BID #24-30-D06
Downtown Campus Paint Equipment
Addendum Two
Released 11/21/2024

ADDENDUM: Addendum Two addresses a clarification to the project manual bid form, clarification to the drawings, questions submitted to the Director of Business Services, the agenda of the pre-bid meeting held on 11/13/24, and the pre-bid meeting attendance.

**ROCK VALLEY COLLEGE
 DOWNTOWN TRAINING CENTER (DTC)**
 ROCKFORD, IL
 DKA PROJECT NO: 23-030

SHEET TITLE:
LEVEL 02 FRAMING PLAN

SHEET NUMBER:
S1.01

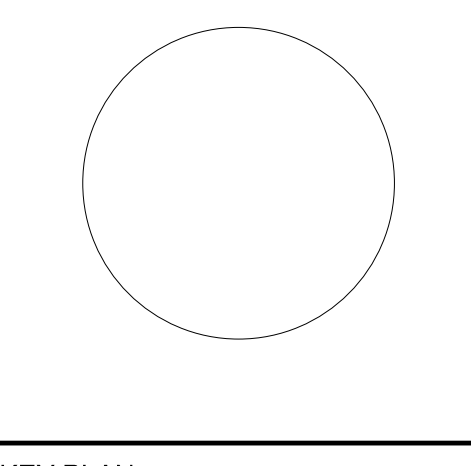
1. S1.01 Level 2 Framing Plan
 - a. Notes added showing clear height between slab and underside of structure.

3. What is the height to the rafters above the booth from the floor?
 - a. See attached S1.01 with heights from floor slab to underside of structure noted.
